BID Addendum-01

Project No.
JCDT23-0185

Title
Bid Clarification 01

Project Name
St Clair County Heath Dept Relocation

Scale	1/8" = 1'-0"
Project No.	JCDT23-0185
Drawing No.	P20-00

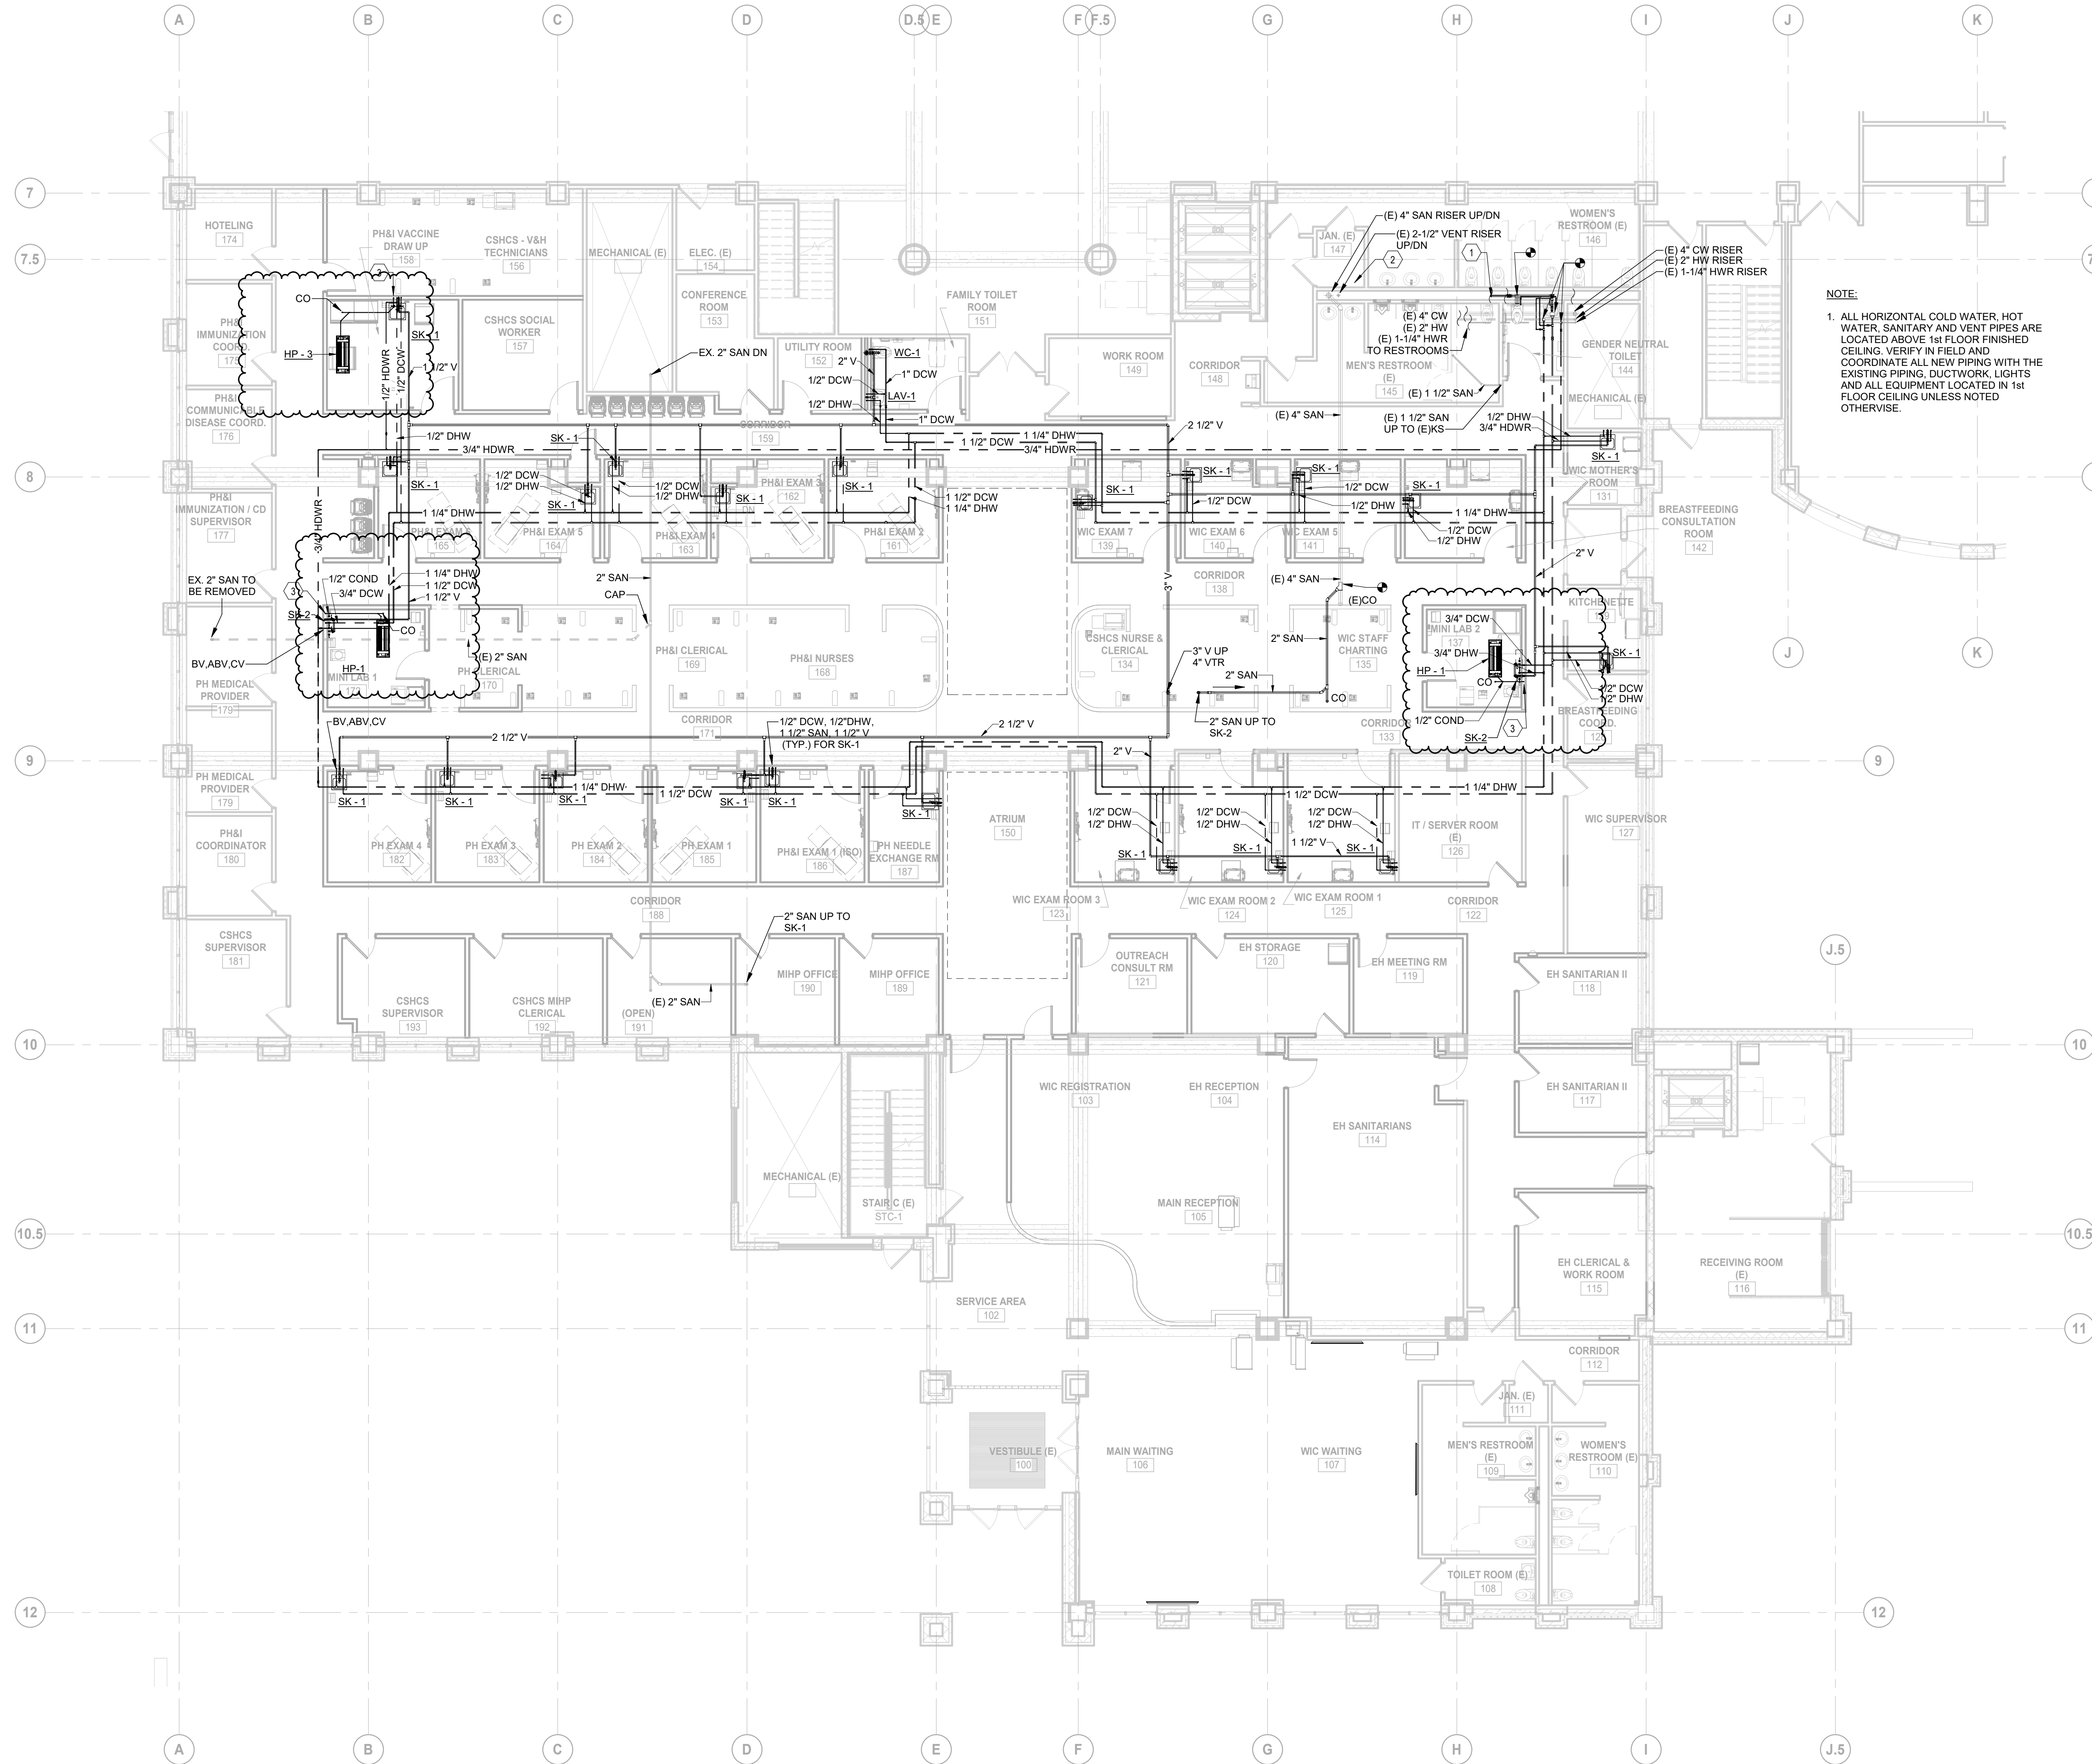
- b. Removed the Water Heater Detail, given there is no new water heater.
21. Dwg No P20-00
 - a. Added existing sump pump on plans.
 - b. Adjusted piping for relocated AHU-1.

1 SOUTH WING - LEVEL 1 ELECTRICAL PLAN
SCALE: 1/8" = 1'-0"

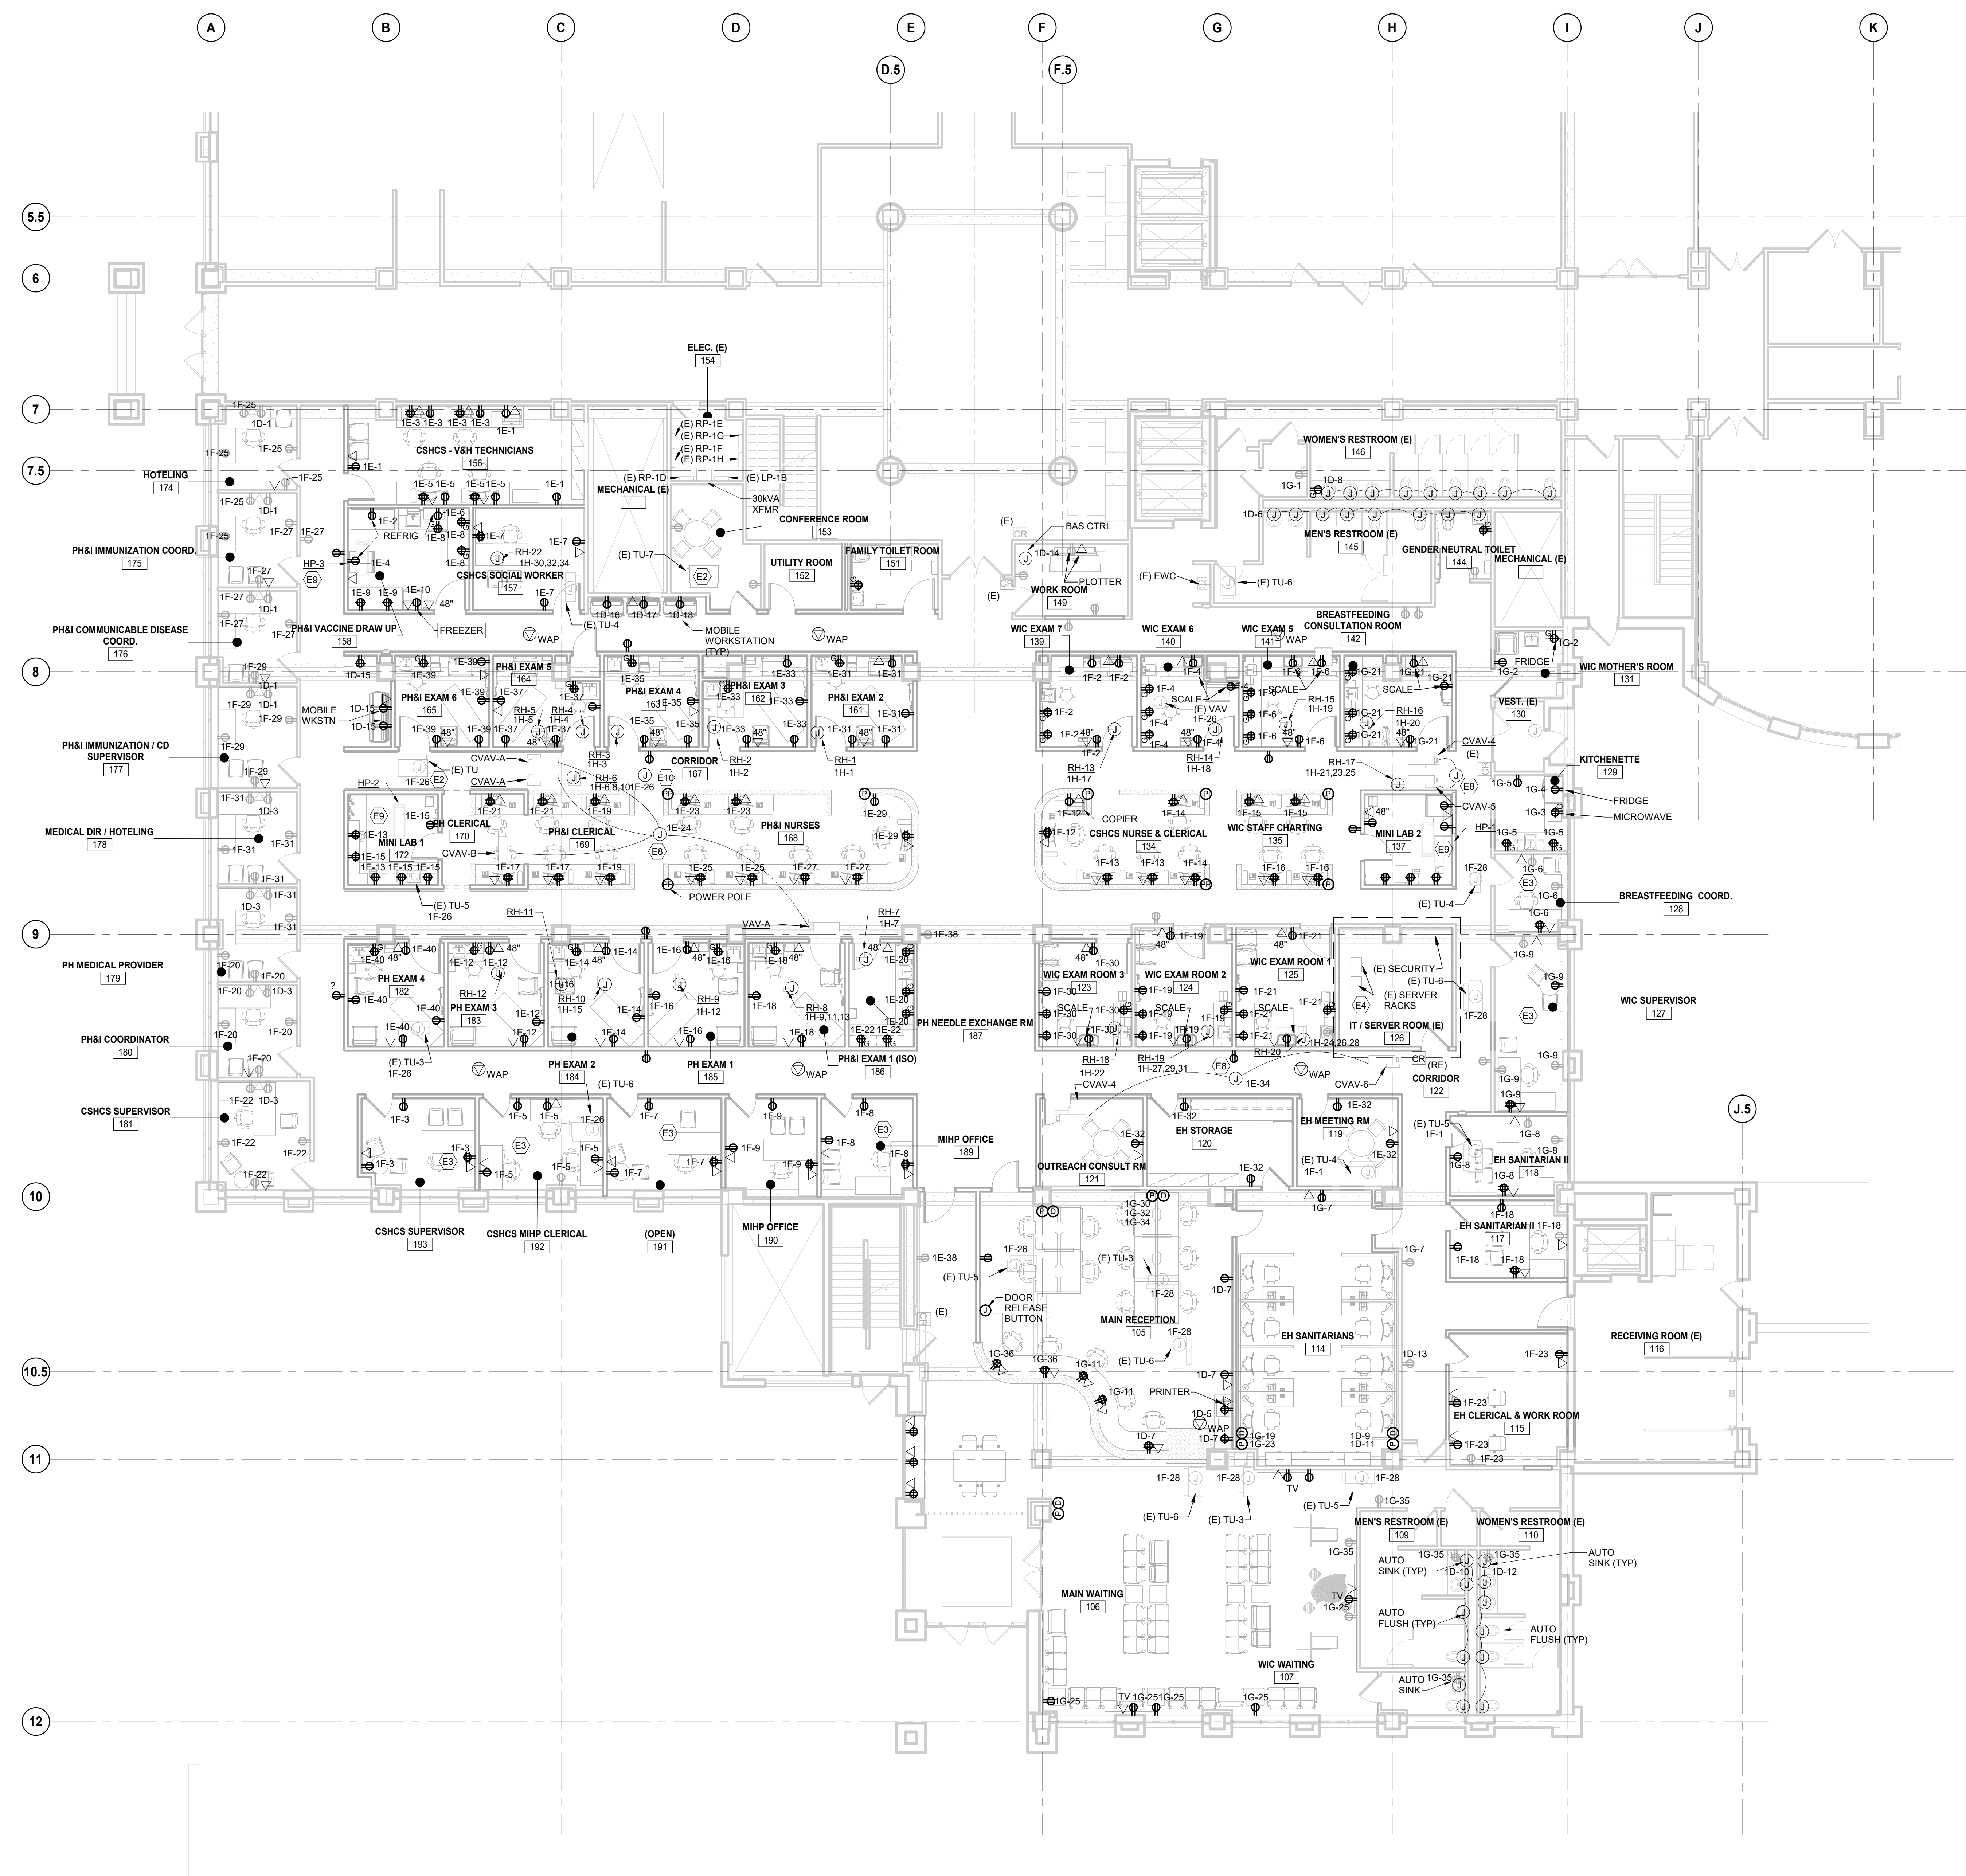
- a. Added power to basement AHU-1 & HU-1.
3. Sheet E10-00 – SOUTH WING – LEVEL 1 ELECTRICAL PLAN
 - a. Added circuiting for receptacles and mechanical equipment.

1 SOUTH WING - LEVEL 2 ELECTRICAL PLAN
SCALE: 1/8" = 1'-0"

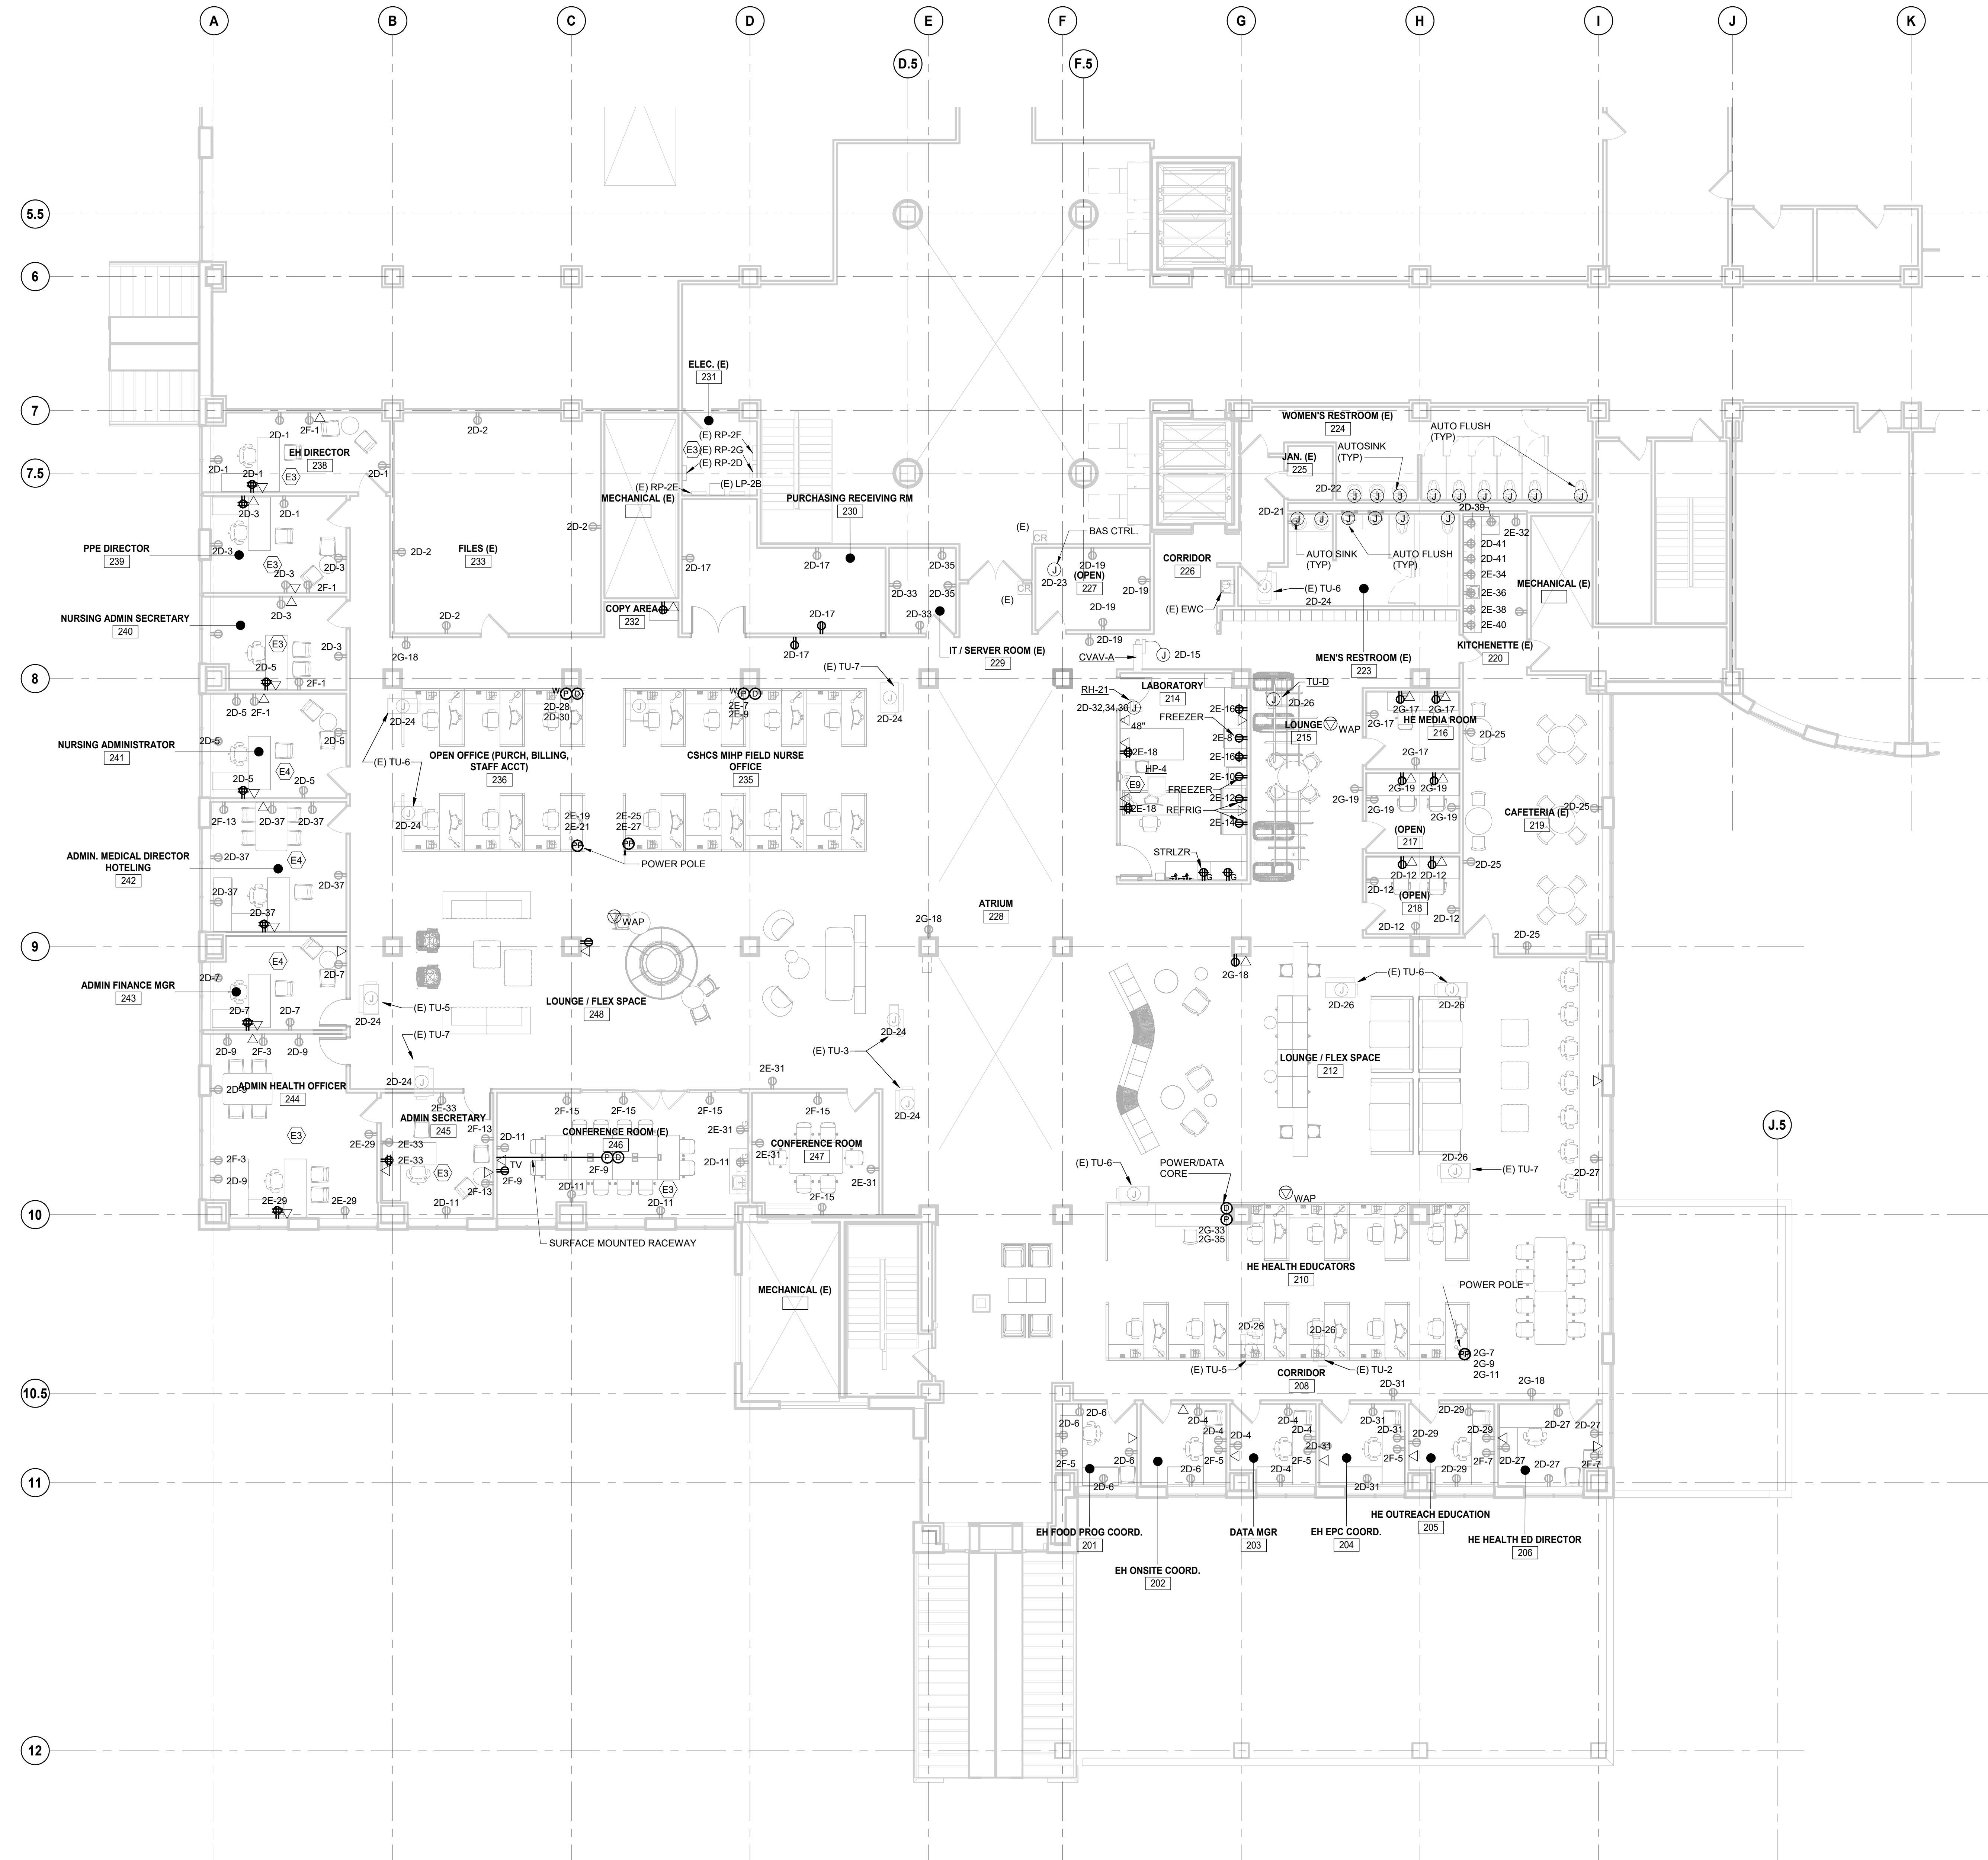
4. Sheet E10-02 – SOUTH WING – LEVEL 2 ELECTRICAL PLAN
 - a. Added circuiting for receptacles and mechanical equipment.
5. Sheet E10-03 – SOUTH WING – ROOF ELECTRICAL PLAN
